**BROOKLYN 1B**  
1309 NE 66TH ST

DESIGN REVIEW RECOMMENDATION  
25 JUNE 2018  
DPD #3026788

ADDRESS: 1309 NE 66TH ST  
PROJECT #: 3026788

NORTH-SOUTH SECTION WITH SURROUNDING PROPOSED CONTEXT

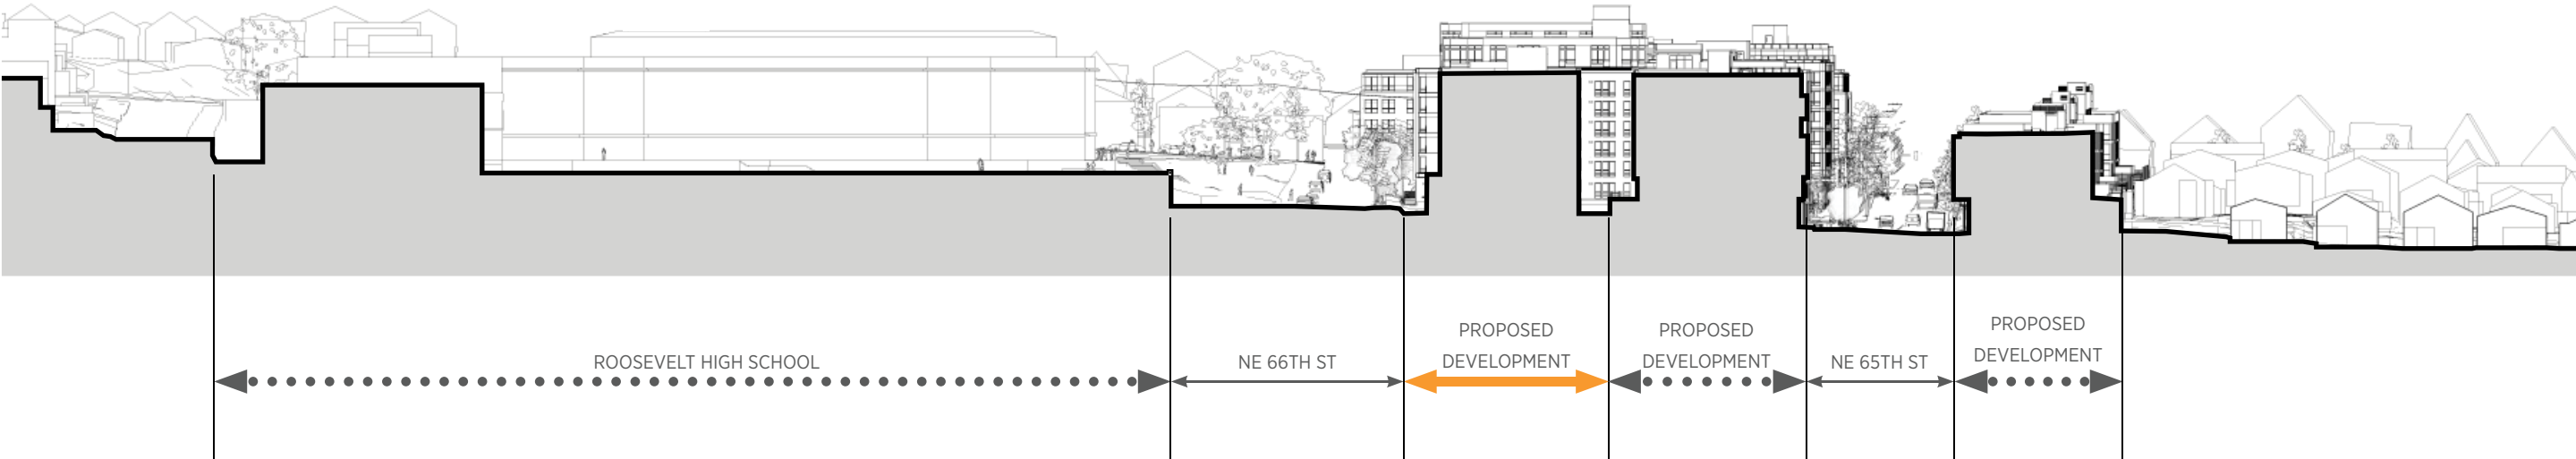
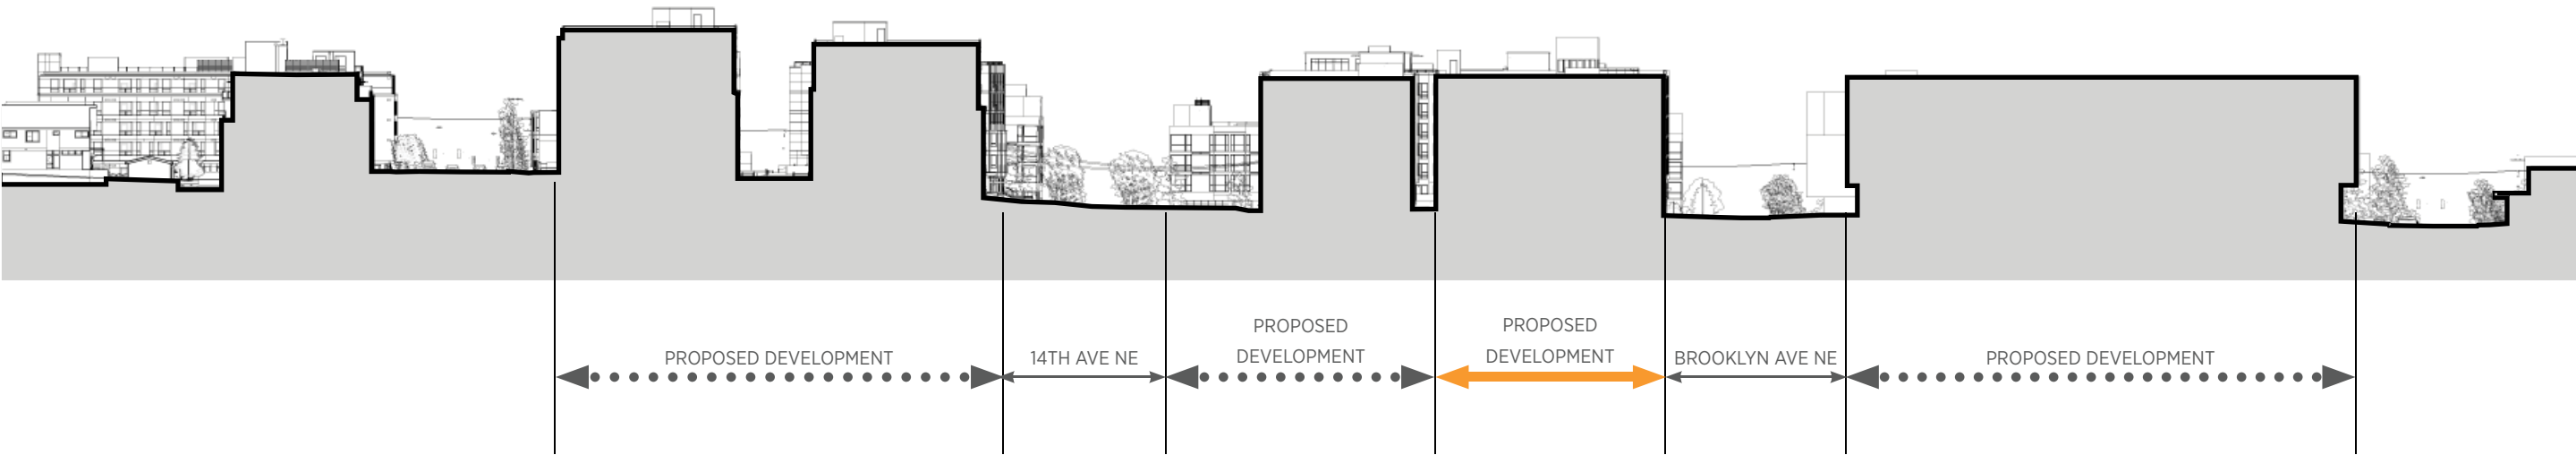
The Board was generally supportive of the preferred massing option (Alternative 3) but echoed public comments about wanting to see how this design proposal fits into the overall context of the neighborhood in through the use of colors, textures, materials, and forms.

a. The Board requested that the applicant provide more images; perspectives, sections that show the overall neighborhood context, including the high school, of the proposed design in relationship to other recently approved projects in the area. The Board was keenly interested in how this project, while being brought forward by the same developer as several other projects in the area, will be different from the others and what will make it unique.

See the sections and perspectives that show neighborhood context, including the high school. The concept of a two sided character is unique in this area. The facade on Brooklyn Ave NE is sleeker and more urban in character while the building is more residential in character facing NE 66th St with private residential patios and decks.

A. PROPOSED SECTION AT NE 66TH ST

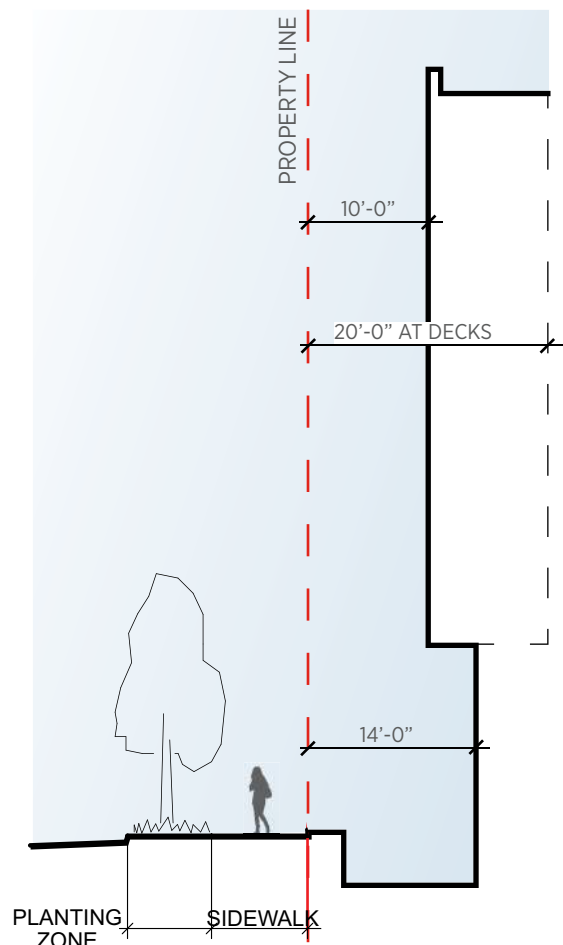
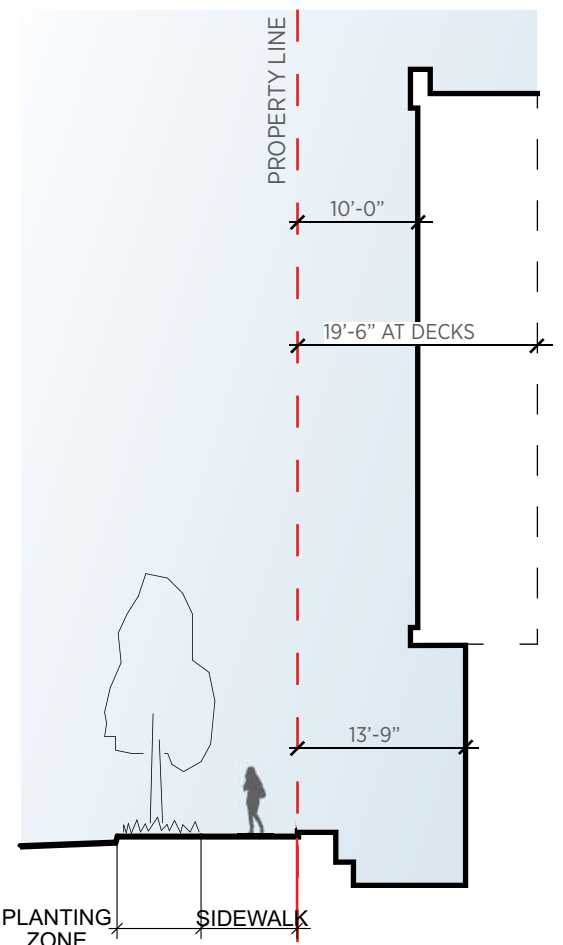
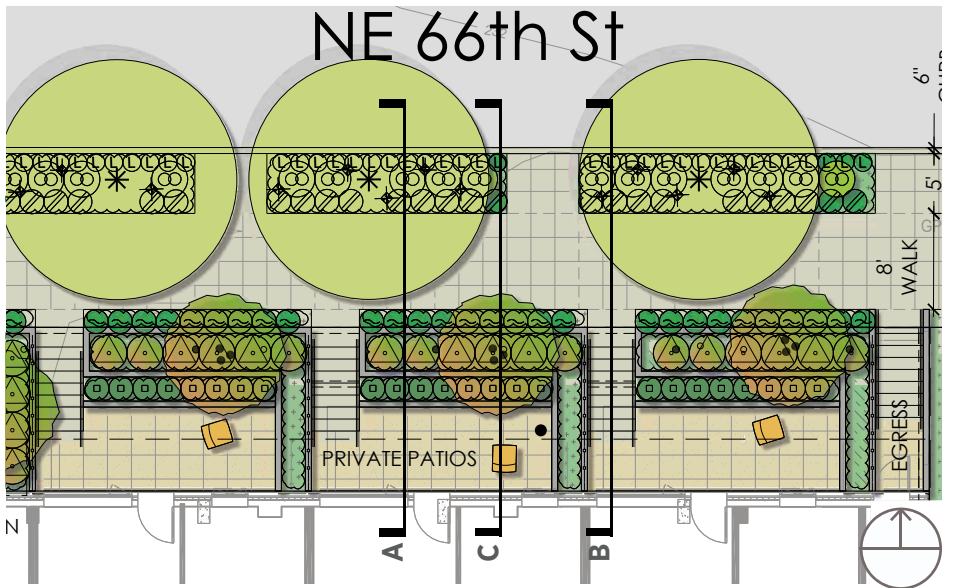
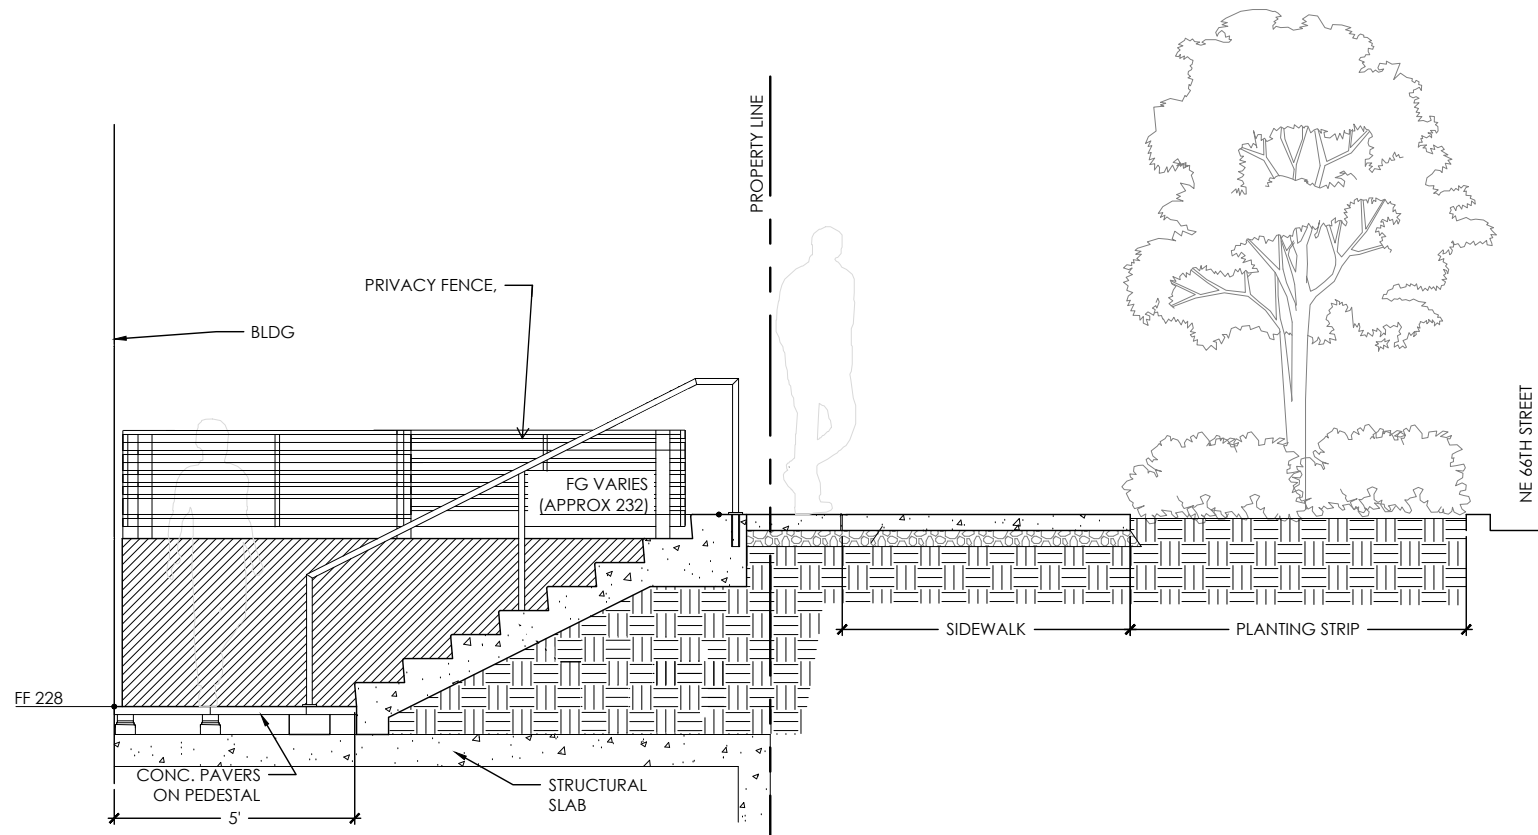
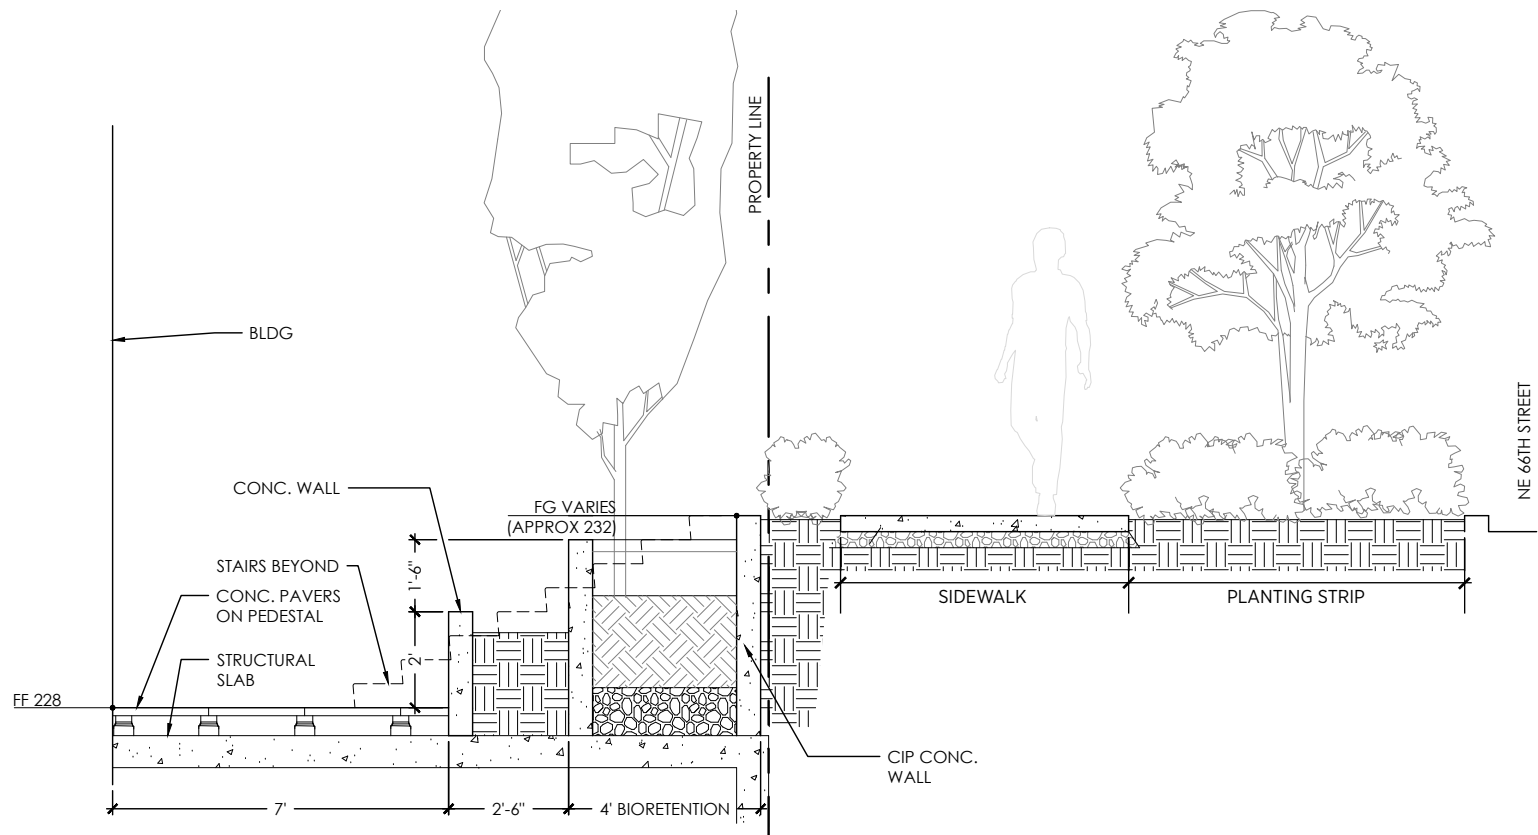
Board members were surprised how the building frontage along 66th Street was set back away from the property line and then stepped down to private patios and questioned why the use of this typology is preferred as opposed to the reverse as would be seen in a more urban stoop type of condition. Board members were concerned that the patio spaces along 66th St. might be excessively large but supported the general concept of creating opportunities for more activity along 66th with the larger than usual building setback.

- a. The Board requested additional sections and other information to demonstrate how this approach is the best design solution.
- b. The Board requested a long section drawing of the street to gain a better understanding of how the sidewalk, setbacks, landscaping, patio and other elements work.

Additional sections and images are provided. Stepped down residential patios are preferred on NE 66th St to tie in neighborhood precedent including the neighboring building to the west. Ground level patios allow more natural light into the ground level units than a raised, urban stoop would. Furthermore, 3 larger patios provide more usable and activated exterior patio space than an urban stoop typology would (small landings to allow light into ground level units).

NE 66TH ST STREETScape, RESIDENTIAL PATIOS AND SIDEWALK TRANSITION

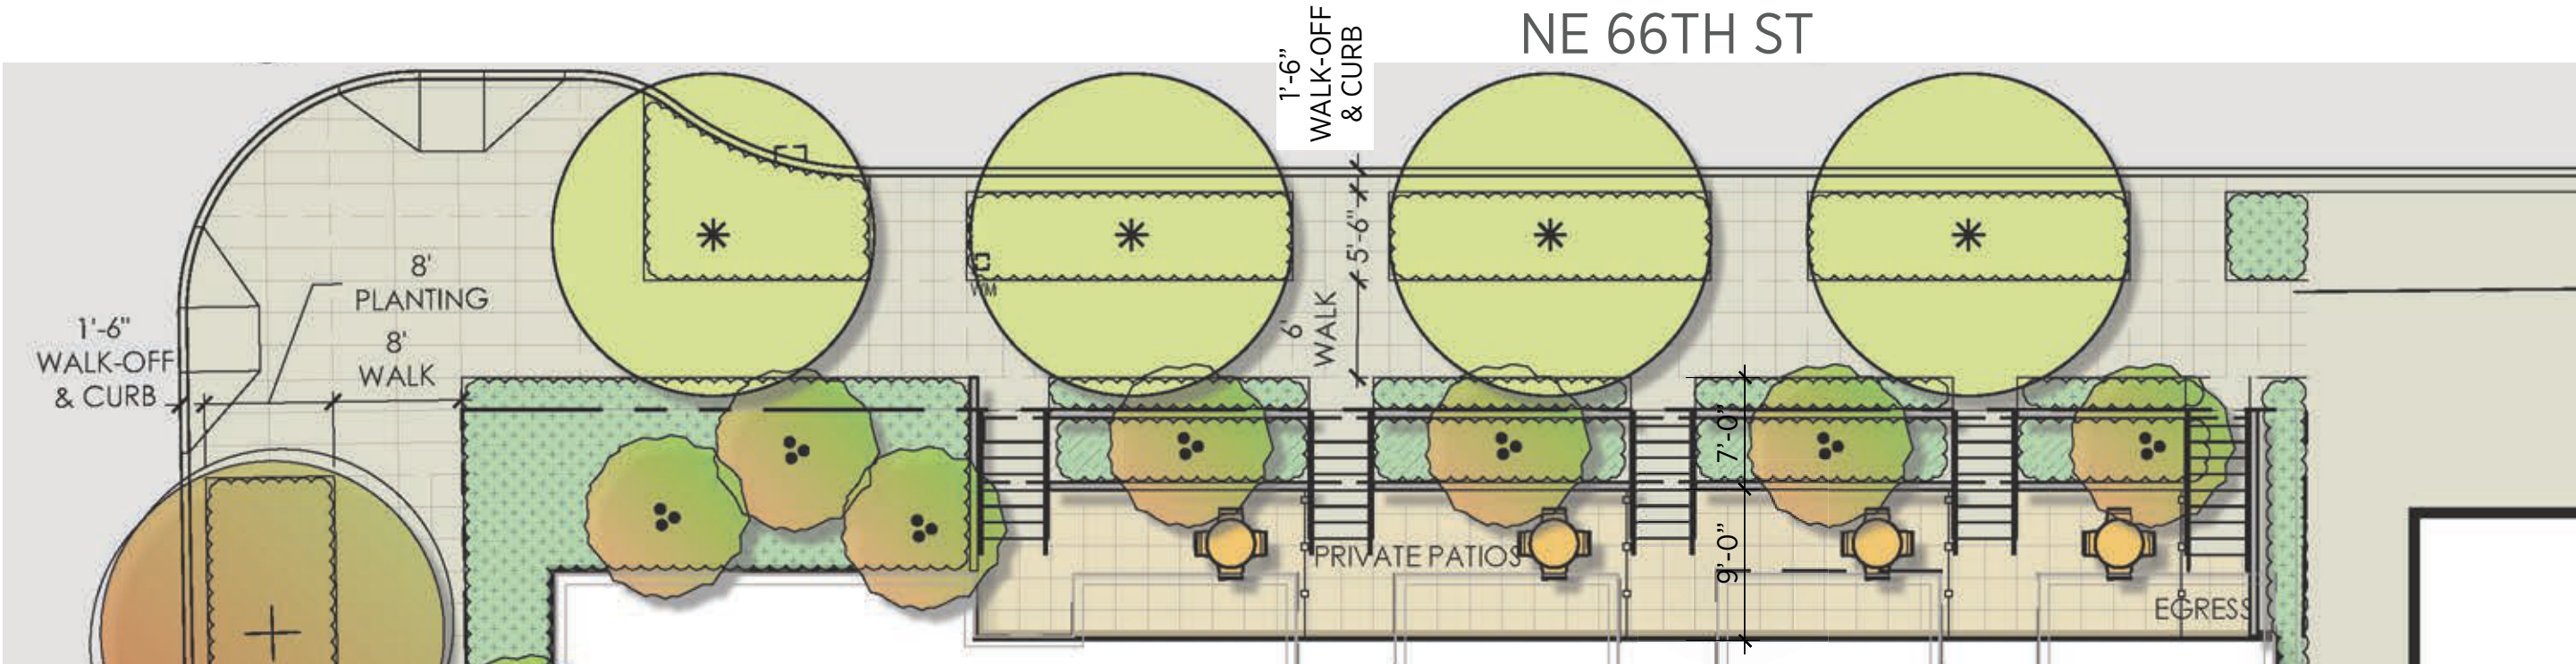
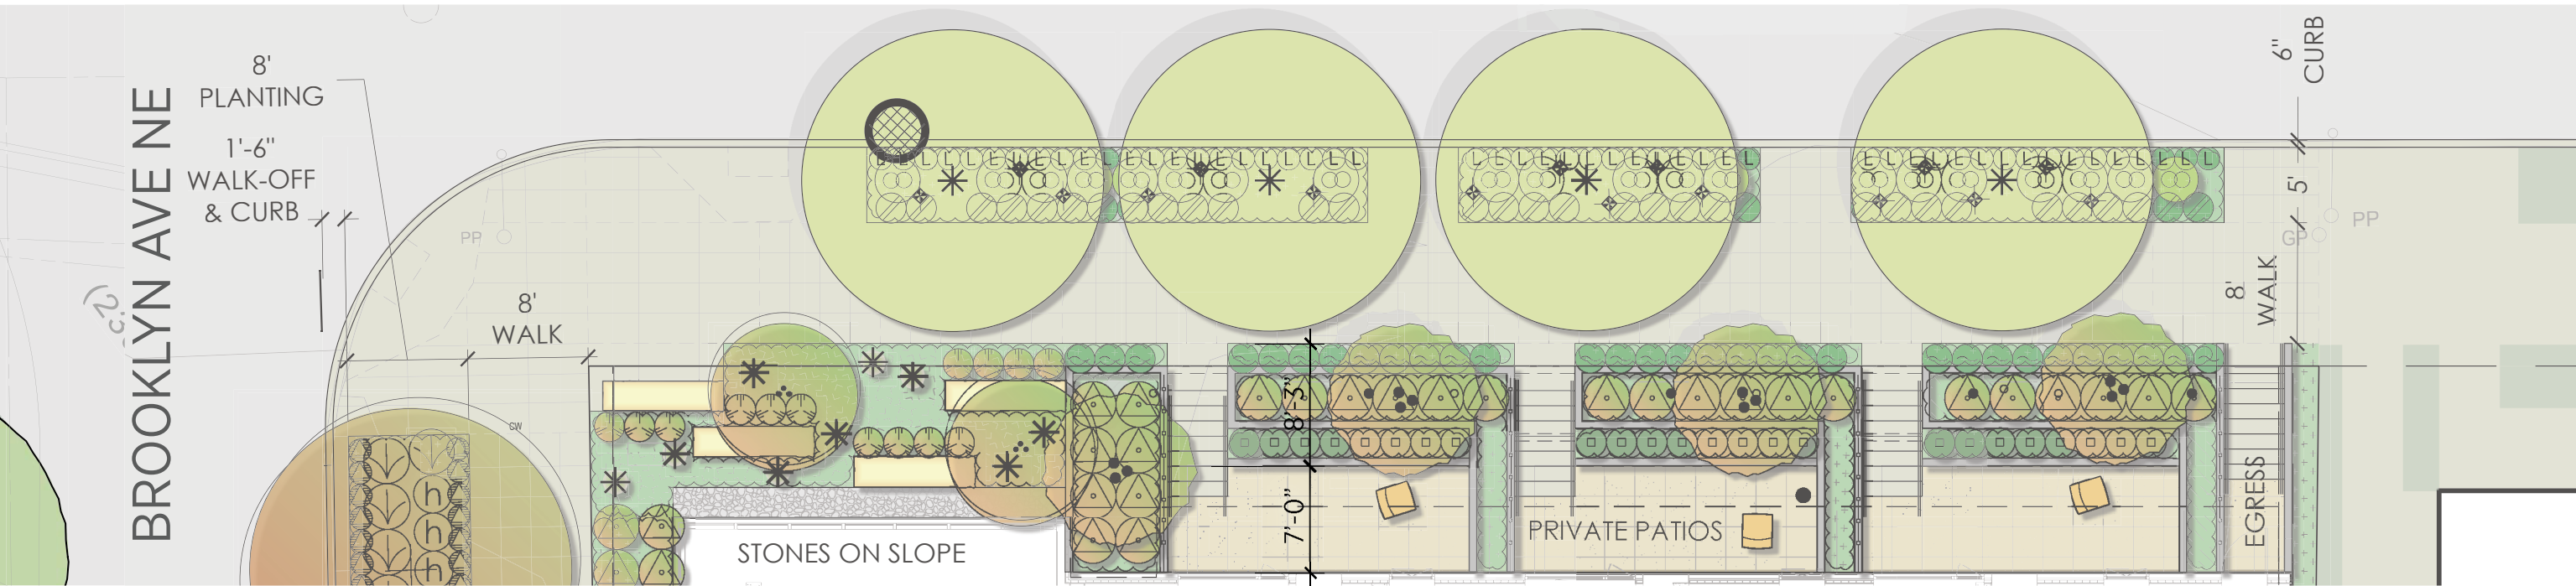
Board members were curious about the width of the sidewalks of the proposal and how it transitions to the sidewalks of the adjacent project to the west.

- a. The Board agreed with public comment and requested that more space be given to the sidewalk width along 66th St., more in line with Seattle Department of Transportation’s (SDOT) recommendation of providing an 8-foot wide sidewalk and a 6-foot wide planter. The Board agreed that one way to achieve this would be to start the landscaping within the property line instead of it protruding forward toward the street, thus allowing more space for sidewalk use.
- b. The Board requested that the residential patios along 66th St. be reduced in depth to allow for additional space to be allocated to the sidewalk width.

The sidewalk width along NE 66th St is in line with SDOT’s recommendation of providing an 8-ft wide sidewalk. Residential patios are reduced in depth. Landscape plans with neighboring context are provided to show sidewalk transition.
